**JULY 15, 2014 ZONING HEARING
“OTHER BUSINESS”
COMMISSION DISTRICT 4**

ITEM OB-43

To consider amending and clarifying zoning stipulations for Can Nguyen regarding rezoning application Z-14 of 2014, for property located on the north side of South Gordon Road, east of Starling Drive; in Land Lots 386 and 412 of the 18th District.

Z-14 CAN NGUYEN (CONT)

C-1

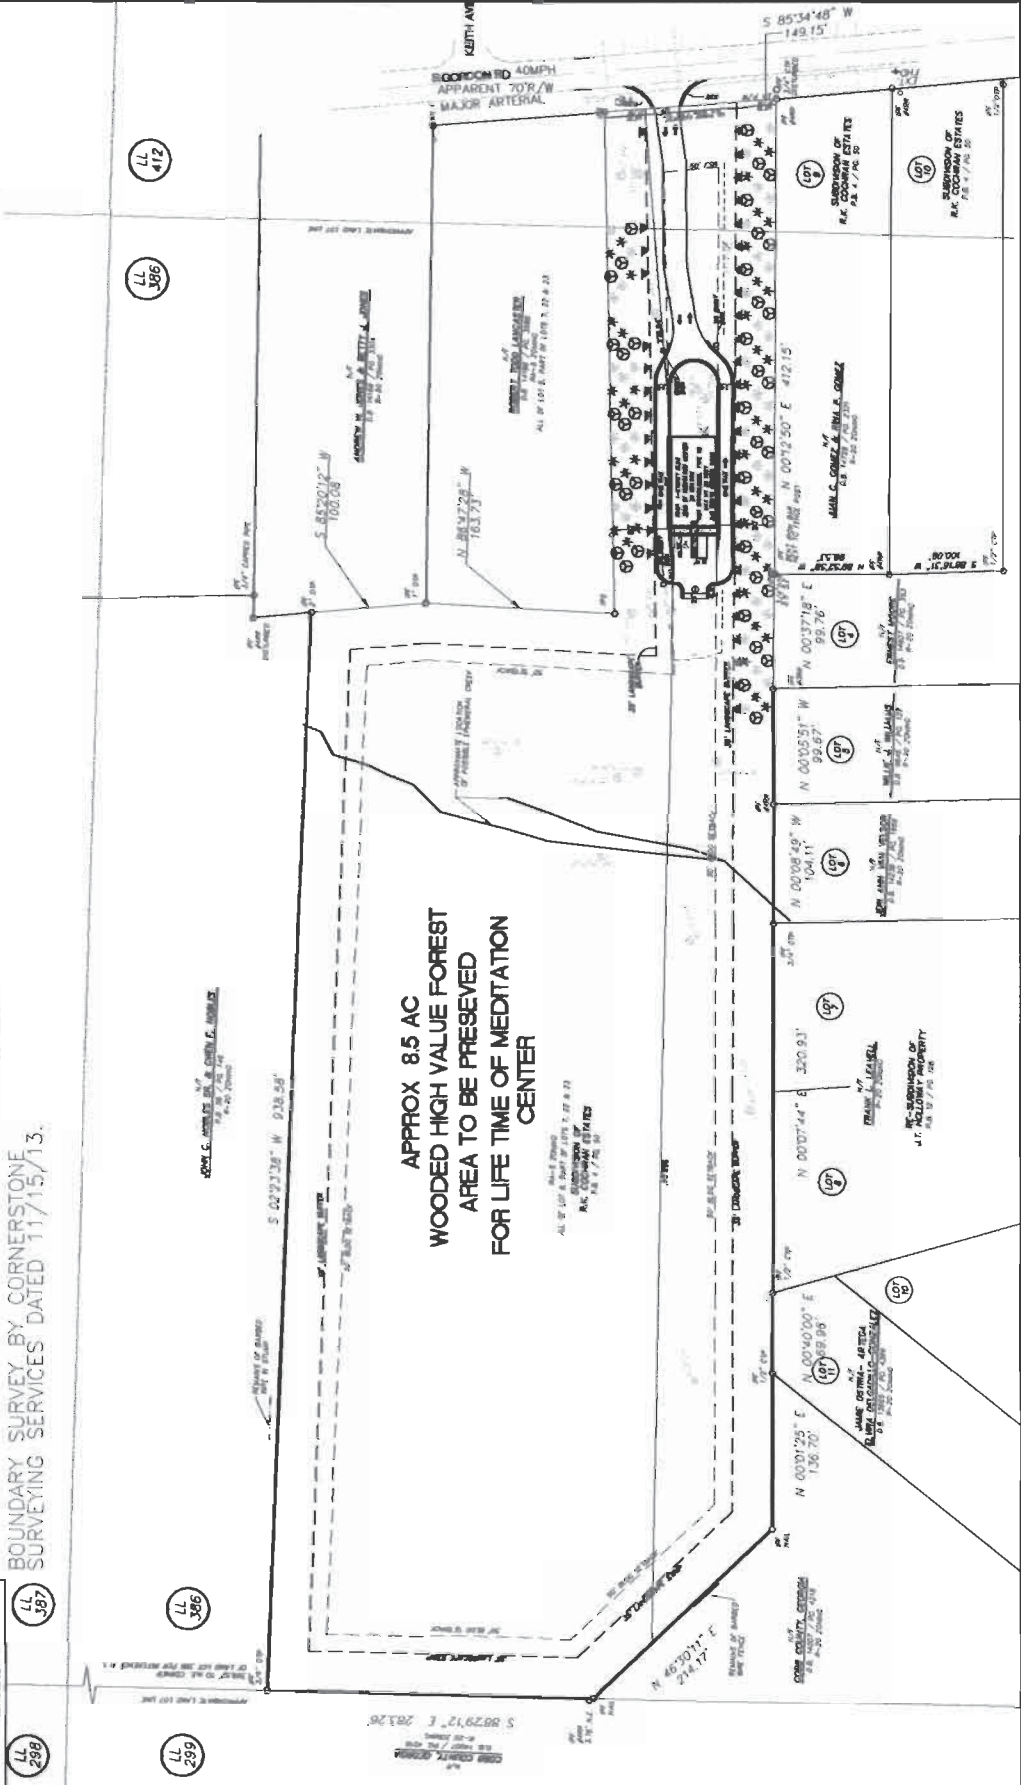
Applicant is requesting the R-20 zoning category for the purpose of having a 3,200 square-foot Vietnam Buddhist Meditation Center. The building will be one-story, brick with metal or asphalt roofing. The proposed site plan indicates the building will be located 50 or more from the property lines and a 35-foot landscape buffer around the perimeter of the property. The site plan also indicates approximately 8.5 acres as wooded high value forest area that will be preserved for lifetime of meditation center. The subject property was rezoned to RA-5 in 2006 (Z-163, minutes attached) for a 46-lot single-family subdivision at a density of 3.88 units per acre.

The required parking for the proposed use is one space per four seats. The site plan indicates the required five parking spaces for 20 seats.

- Provide comprehensive hydrology/stormwater controls to include development of out parcels.
- Submit all proposed site improvements to Plan Review.
- Any **spring activity** uncovered must be addressed by a qualified geotechnical engineer (PE).
- Structural fill _____ must be placed under the direction of a qualified registered Georgia geotechnical engineer (PE).
- Existing facility.
- Project must comply with the Water Quality requirements of the CWA-NPDES-NPS Permit and County Water Quality Ordinance.
- Water Quality/Quantity contributions of the existing lake/pond on site must be continued as baseline conditions into proposed project.
- Calculate and provide % impervious of project site.
- Revisit design; reduce pavement area to reduce runoff and pollution.

- No Stormwater controls shown _____
- Copy of survey is not current – Additional comments may be forthcoming when current site conditions are exposed.
- No site improvements showing on exhibit.

- Site plan received by the Zoning Division on February 6, 2014, with the District Commissioner approving minor modifications;
- Fire Department comments and recommendations;
- Water and Sewer Division comments and recommendations;
- Stormwater Management Division comments and recommendations;
- Department of Transportation comments and recommendations; and
- Owner/developer to enter into a Development Agreement pursuant to O.C.G.A. §36-71-13 for dedication of system improvements to mitigate traffic concerns.
